Access Compliance Report Public Rights-of-Way (Curb Ramps)

Main Street: SHADBURN_AVE Cross Street: HAMER_DR Location: SE

ADA ID: RPAT210917125001 Ramp Type: Type 1 - Perpendicular Diagonal Initial Pass/Fail: Pass Overall Compliance: No Severity Score: 9

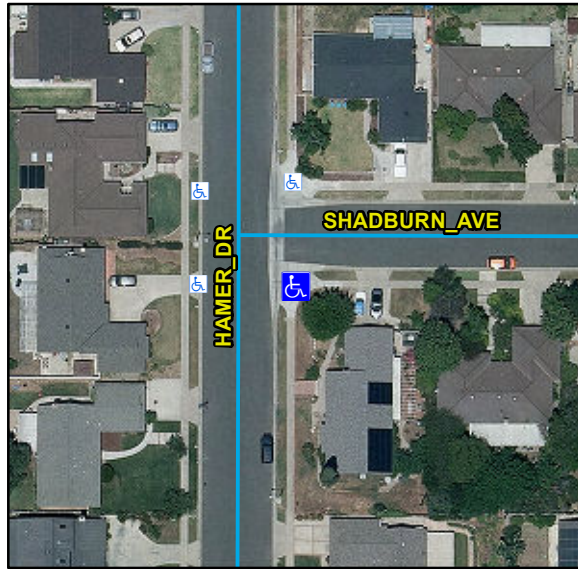
R304.2.2, R304.2.1, R304.5.4, STD 1115

Compliance	Description	Data	Compliance	Description	Data
N/A	Ramp Length (in)	55	N/A	Flare Type LT	
Yes	Ramp Width (in)	48			Sloped
Yes	Ramp Run Slope (%)	7.6	N/A	Flare Slope LT (%)	10.7
Yes	Ramp Cross Slope (%)	3.8	N/A	Flare Traversable LT	No
N/A	Landing Present	Yes	N/A	Flare Type RT	
N/A	Landing Length (in)	45			Sloped
Yes	Landing Width (in)	48	N/A	Flare Slope RT (%)	1.8
Yes	Landing Run Slope (%)	0.9	N/A	Flare Traversable RT	No
Yes	Landing Cross Slope (%)	4	Yes	DWS Provided	Yes
N/A	Landing Movement Obstructed?	Yes	Yes	DWS Contrast	Yes
	Landing Movement Type	Wall	Yes	DWS Length (in)	36
N/A	Landing Shared	No	Yes	DWS Full Width	Yes
N/A	Clear Space	Yes	Yes	DWS Offset Left (in)	0
N/A	Clear Space To Crosswalk (in)	48	Yes	DWS Offset Right (in)	N/A
N/A	Marked Crosswalk 1	No	N/A	Marked Crosswalk 2	No
	Crossing 1 Direction	N		Crossing 2 Direction	W
	Marked Crosswalk 1 Width (in)	N/A		Marked Crosswalk 2 Width (in)	N/A

N/A	Ramp Inside Crosswalk 1	N/A	Yes	Ramp Inside Crosswalk 2	N/A
	Crossing 1 Slope (%)	2.3		Crossing 2 Slope (%)	6.5
	Crossing 1 Cross Slope (%)	7.8		Crossing 2 Cross Slope (%)	0.7
Yes	Gutter Ponding	No	No	Curb Slope	13.6
Yes	Gutter Lip Height (in)	0		Road Run Slope (%)	5.5
No	Gutter Run Slope (%)	5.6		Road Cross Slope (%)	0.4
Yes	Gutter Cross Slope (%)	4.7			
Yes	Overall Surface Condition: Acceptable		Yes	Perp Joint Present	Yes
	Cross Gutter Present?	Yes		Spandrel Present?	Yes
	Replace Cross Gutter?	No		Replace Spandrel?	No

Remove & Replace Curb Ramp With Two New Directional Ramps or Equivalent. Remove & Replace Gutter.
